**Agilent Technologies**  
**85027E**  
**Directional Bridge**  
**Operating and Service Manual**  
**85027-90014**

# MANUAL CHANGES SUPPLEMENT

## HP 85027E Directional Bridge Operating and Service Manual

Manual Change Supplement Part Number: 85027-90020

Figure 4-a. Directivity Performance Test Setup

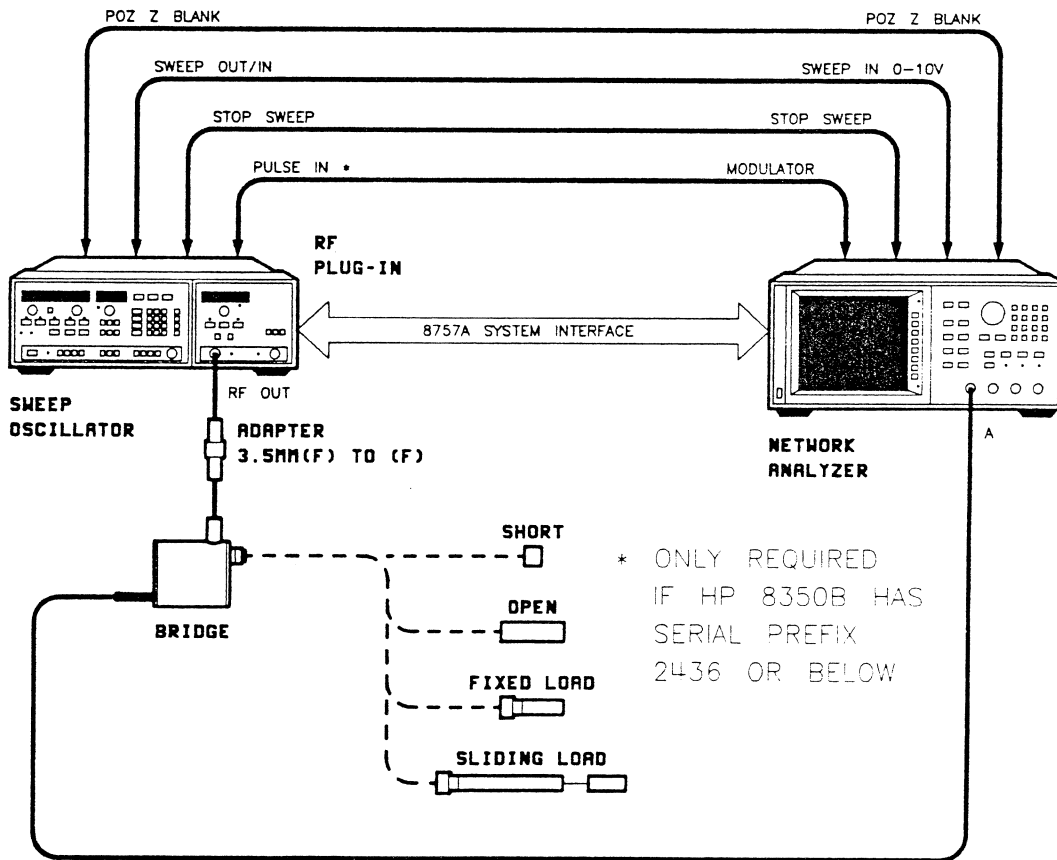
1. Connect the equipment as shown in Figure 4-a. Do not connect anything to the bridge test port yet.

Figure 4-b. Measurement Uncertainty from 0.01 to 20 GHz

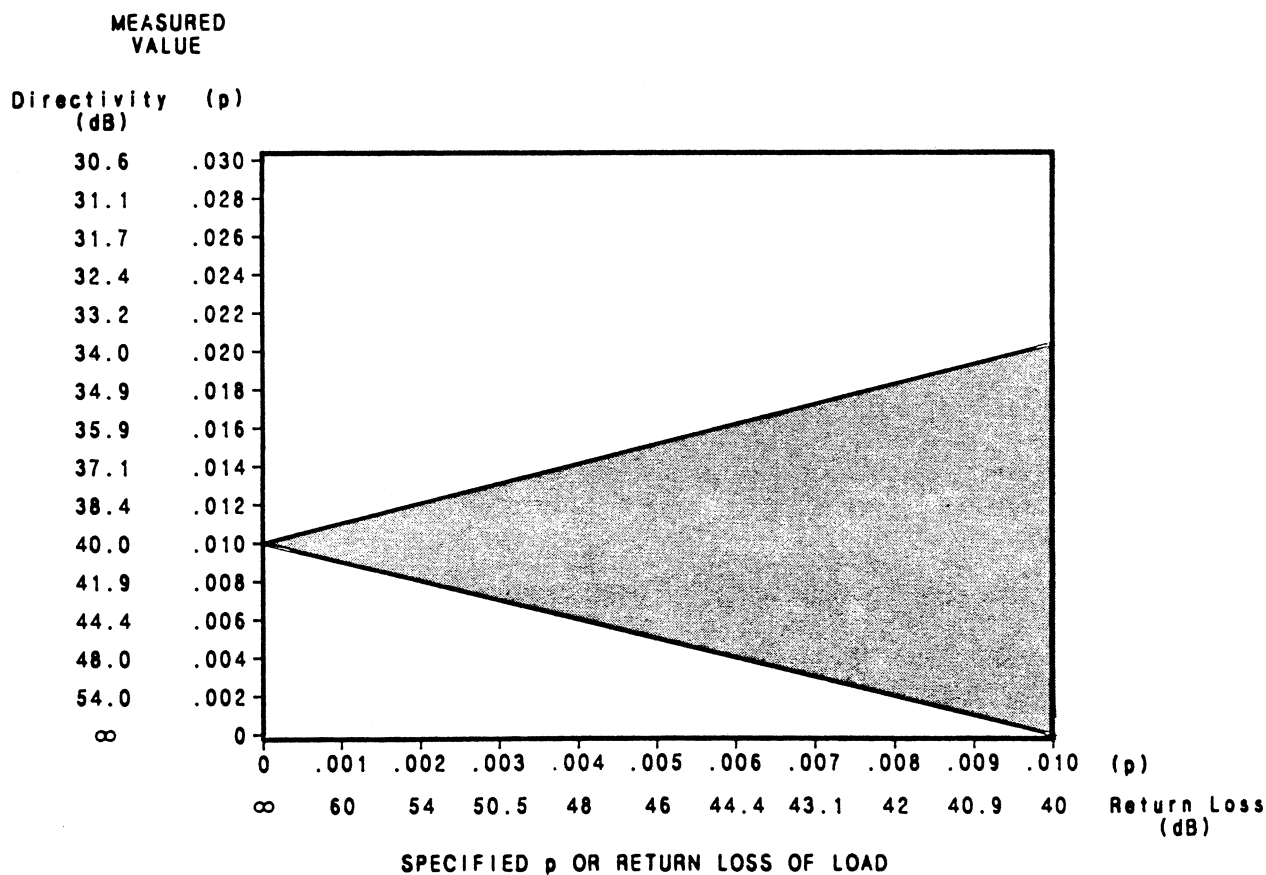
Figure 4-b shows worst case uncertainty for loads with a given return loss. When performing this test, it is likely that the measured directivity will be less than the specified directivity of the bridge. Again, this is most likely the fault of the load being used in the test. Under these circumstances, it is difficult to prove the performance of the bridge. However, if measured directivity falls within the tolerance shown in Figure 4-b, there is a 90% probability that the bridge meets or exceeds its specification.

6. Refer to Figure 4-b. The chart shows the measurement uncertainty range as a shaded area. This is relative to the specified directivity of the bridge (40 dB). To determine measurement uncertainty, locate the reflection coefficient ( $\rho$ ) or return loss of the fixed load on the horizontal axis (the HP 909D's  $\rho$  is 0.01). Move up from that point to the shaded error limit window. The actual directivity could be anywhere within the error limit lines (read maximum and minimum possible values on the vertical axis). For the HP 909D option 040, move up from the 0.010 value on the horizontal axis, actual directivity could be anywhere from 34 db to infinity (read on the vertical axis). Record the uncertainty in the test record.

Any measured directivity **below** the shaded area on Figure 4-b ensures conformance to specification. A measured directivity **anywhere within** the shaded area indicates a 90% probability that the product meets specified directivity. This is based on factory observations.

15. Although the signal separation procedure removes reflections of the load itself, the mismatch of the sliding load connector and airline introduces reflections and uncertainties. To estimate these uncertainties, refer to Figure 4-b. Locate the return loss of the sliding load connector on the horizontal axis (convert from the specified SWR). Move up from this point to the upper limit of the shaded area of the chart. Find the corresponding dB value on the vertical axis and enter this value in the test record. Actual directivity can be anywhere within the shaded area. Record the uncertainty in the test record.

Figure 4-c. Signal Separation Chart

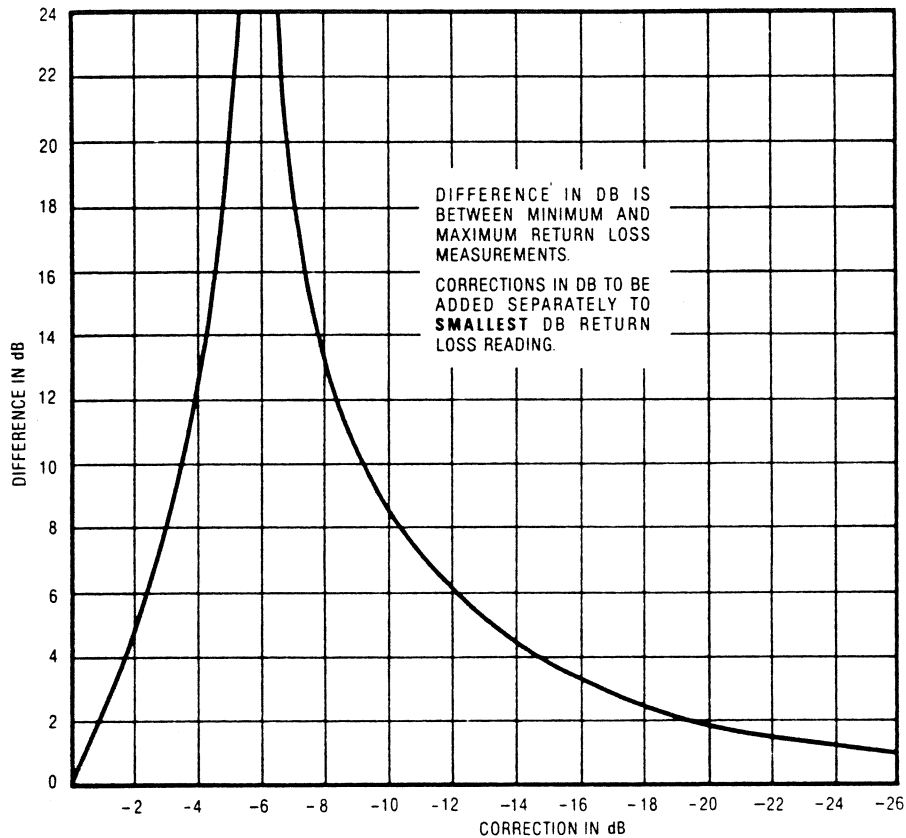
11. The maximum and minimum measured return loss values correspond to the directivity signal and the sliding load signal adding and subtracting. You can separate these two signals with the signal separation chart, Figure 4-c. Calculate the difference in dB between the maximum and minimum measured return loss for the first chosen frequency and locate this value on the vertical axis of Figure 4-c. Draw a horizontal line across the chart from this point and note the two places where it intersects the curves. The intersections are the two correction values in dB. Add each of them to the minimum measured return loss. The resulting two corrected values are the directivity signal and the sliding load reflected signal. Exactly *which* value represents directivity is determined later in this procedure.

**Example:** At 3 GHz you measure a maximum measured return loss of  $-42$  dB and a minimum return loss of  $-30$  dB. The difference is 11 dB. Refer to Figure 4-c. Find 11 dB on the vertical axis, and draw a horizontal line across the figure from that point. Note the correction values on the horizontal axis are  $-4$  dB and  $-8.5$  dB. Adding each of these to the minimum measured return loss results in two values:  $-34$  dB and  $-38.5$  dB. One of these values is the directivity value, the other is the return loss of the sliding load's load element.

Figure 4-d. Measurement Uncertainty above 20 GHz

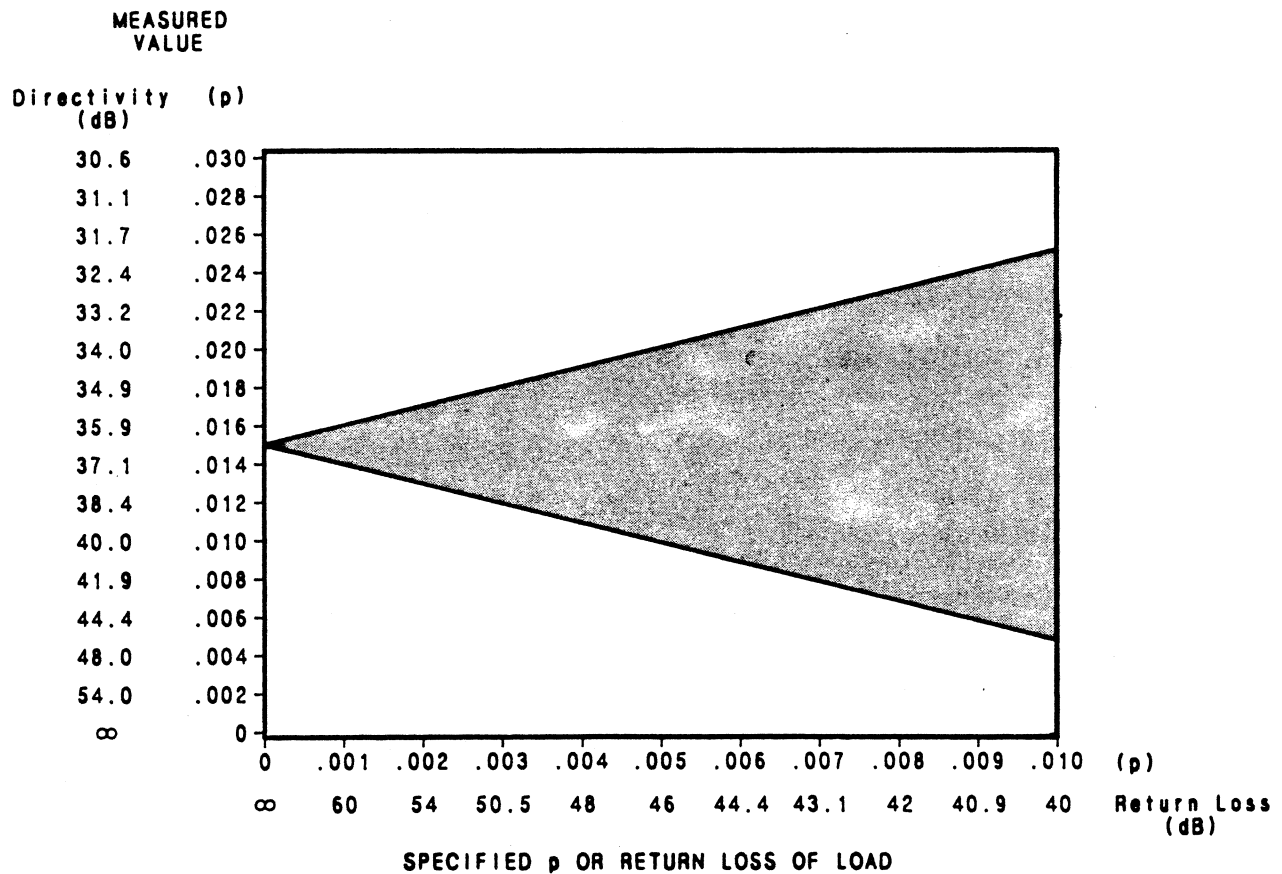
**NOTE:** When determining measurement uncertainty for frequencies above 20 GHz, refer to Figure 4-d instead of 4-b. The directivity specification changes above 20 GHz and this affects the uncertainty chart.
